ZONING BOARD OF APPEALS

ZBA 2008-74

Petition of Wellesley Realty Associates
 978 Worcester Street

PROPOSED SITE PLAN

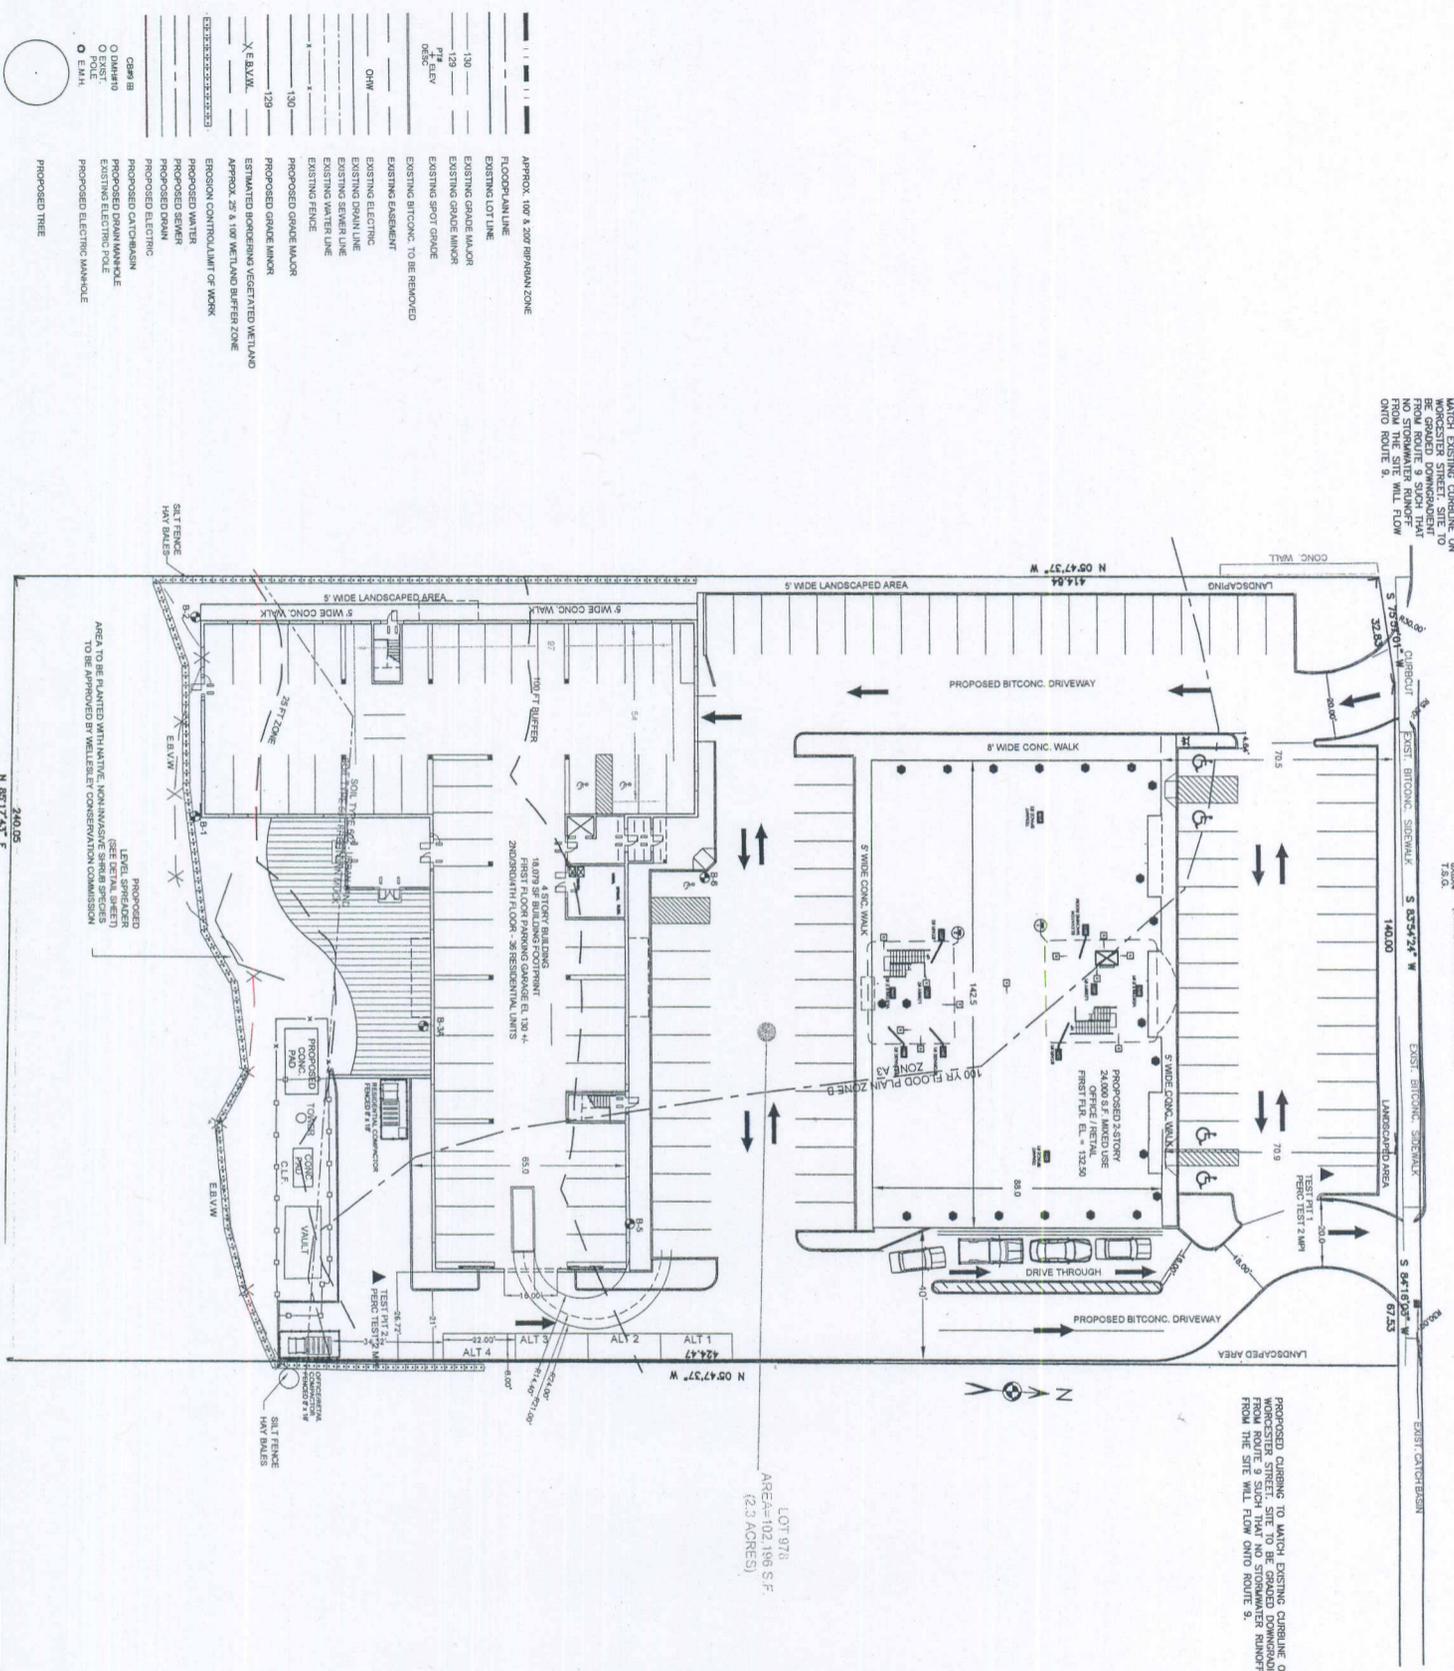
With the exception of the Proposed Site Plan, sheet#2, which according to Beals Associates, Inc., will be prepared shortly to show three (3) permanent benchmarks triangulated and located on the plan and be stamped and signed by a Massachusetts licensed registered land surveyor, the applicant has addressed previous comments in a memo dated November 21, 2008, submitted to the Zoning Board of Appeals from this office.

PARKING AND PEDESTRIAN PLAN

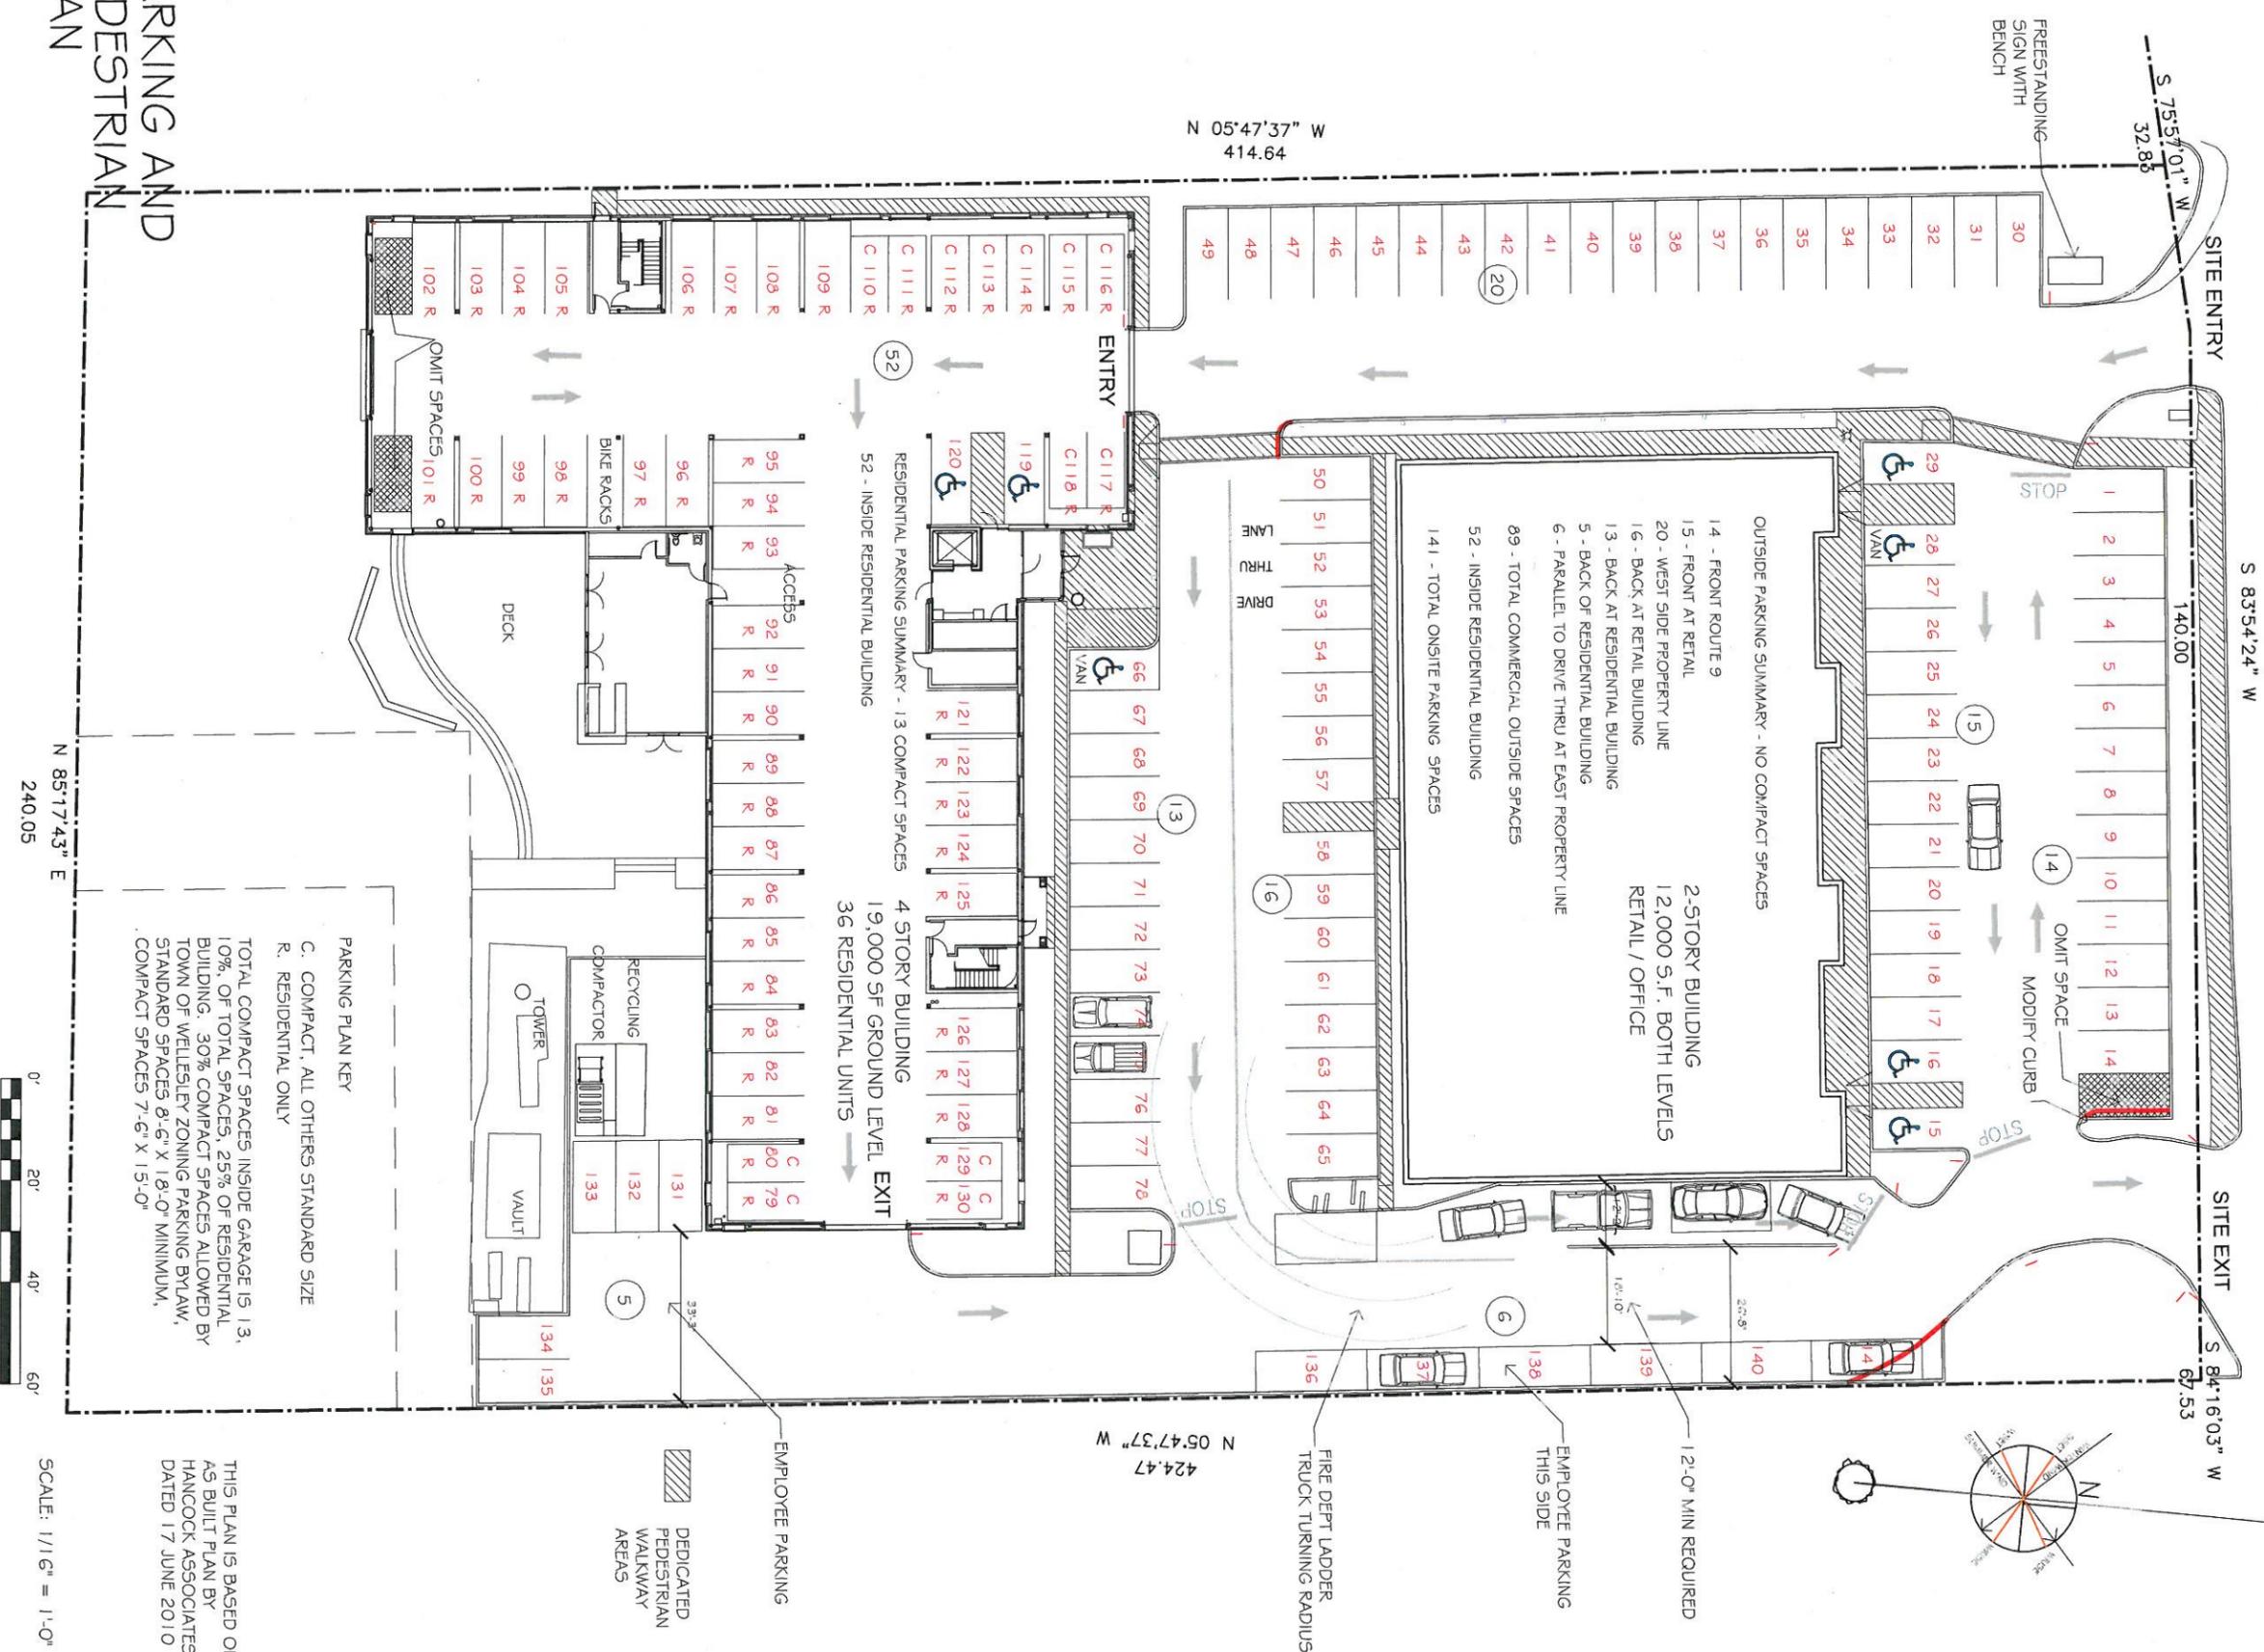
The Board said that originally it had some concerns about the spaces that are marked 50-65 on the new plan. The Board said that it had been concerned that queuing for the drive-through could possibly block those spaces. The Board asked if those spaces are designated for employee parking. Mr. Brewer said that currently the only employees are for Dunkin Donuts. He said that as the use of the space evolves, if there is conflict in that area, the intent will be to minimize those conflicts by making those spaces dedicated employee parking. Mr. Behrend said that they felt that since the travel lane for Dunkin Donuts was designated as an active lane and the cars parked in spaces 50-65 would not be going in and out actively, it made sense for employee vehicles to be parked there.

The Board said that, on the approved plan, there was no parking on the easternmost edge. Mr. Brewer said that after Site Plan Approval, the building was shifted a couple of feet. He said that there is a drive aisle space for Dunkin Donuts of over 12 feet. He said that there is almost 19 feet between the parking space and the curb. He said that they moved the alternate spaces to where they thought would be a better location.

The Board said that there are required setbacks from parking spaces. Mr. Brewer said that the 24 foot drive aisles were maintained. The Board said that the 24 foot drive aisles were shown on the approved plan but the building was shifted. The Board said that the 24 foot drive aisles should be shown on the proposed plan. The Board asked how the 24 foot drive aisle was achieved after the building was shifted. Mr. Brewer said that some of the space was removed from the green strip. The Board said that the green strip was 5 feet wide in the approved plan and it appears to be the same in the proposed plan. The Board said that a plan should be submitted with dimensions.

The Board asked about the number of parking spaces. Mr. Behrend said that the proposed plan has 141 spaces. He said that they picked up some space by the dumpsters. He said that the cell tower boxes have been reconfigured and condensed. He said that there is now more space at the back.

The Board said that conditions of the Modified Site Plan Approval would be that all of the dimensional requirements of the Zoning Bylaw be complied with, a Zoning Analysis be provided indicating the number of spaces and their uses, and a sign off from the Fire Department be submitted.

1. All Site Plan dimensional requirements of the Zoning Bylaw shall be complied with.
2. A Zoning Analysis shall be submitted indicating the number of parking spaces and their uses.
3. A sign off from the Fire Department shall be submitted.
